TO: Freightliner Principals, General Managers, Sales Managers, Service Managers, Parts Managers	FROM: Anthony Washington, Department Manager, Regulations and Certifications
<b>Re: Recall Campaign Launch Notification Model - Sprinter Model Years 2019-2020 Modify Interior Blower Motor Fuse Layout NHTSA ID - 23V100</b>	DATE: June, 2023

<b>Campaign No. :</b>	<b>Campaign Desc. :</b>	Modify Interior Blower Motor Fuse Layout
<b>2023040008</b>	<b>VS30SIGEBL</b>	
<p>This is to notify you of a <b>Recall Campaign Launch</b> to modify the interior blower motor fuse layout on approximately <b>3,539</b> MY19-20 Freightliner Sprinter vans. The recall campaign will be visible on the <a href="http://www.safercar.gov">www.safercar.gov</a> website and may generate questions from customers. All affected VINs will be flagged “<b>OPEN</b>” in VMI and <b>cannot be sold</b> until remedied.</p>		
<b>Background</b>		
<b>Issue</b>	<p>Mercedes-Benz AG (“MBAG”), the manufacturer of Freightliner vehicles, has determined that on certain Sprinter (907 platform) vehicles, the fuse layout of the interior blower motor might not meet the requirements for prolonged operation at the highest blower setting. Ambient and

D83.10-A024-79

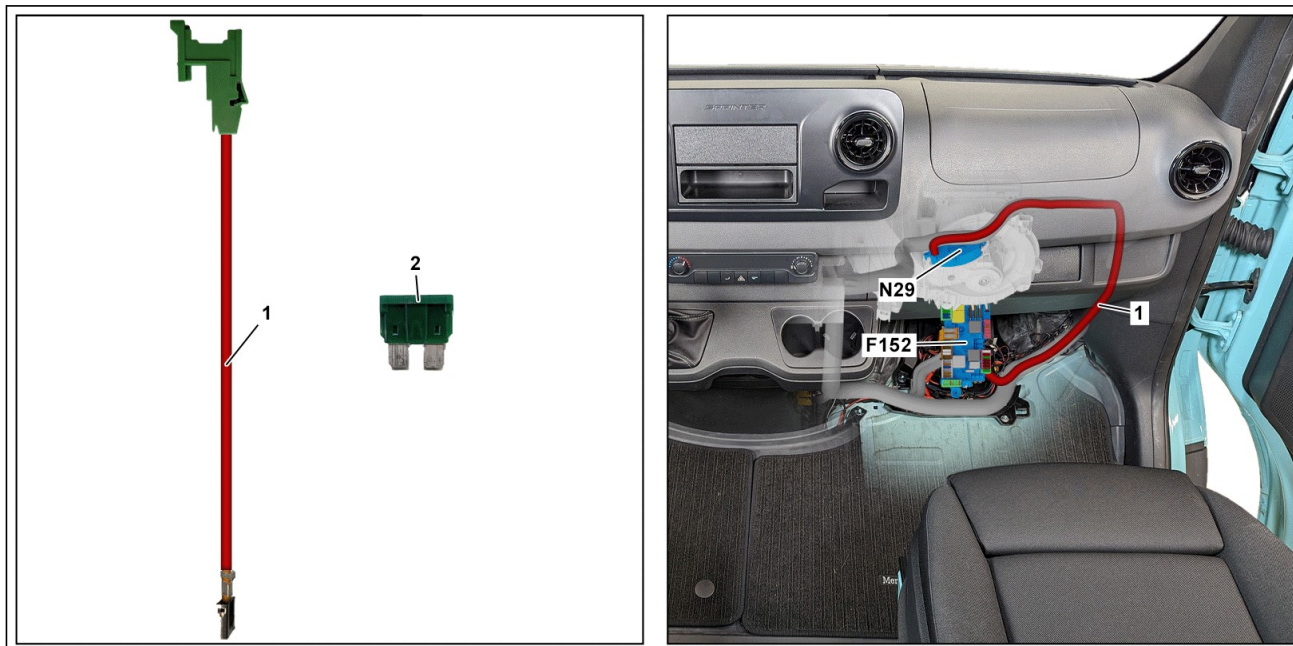
4.2 	Remove bottom trim for instrument panel on front passenger side.	Model 907  except code FJ4 (Stowage compartment under cockpit)	AR68.10-D-1502TSF
	<b>Retrofit electric lines (1)</b>		
5	Retrofit electric line (1) for power supply of blower regulator of inner blower (N29).	 Wiring harness repair kit, basic	SM83.10-D-0013-02SG  <a href="#">000 589 13 99 00</a>
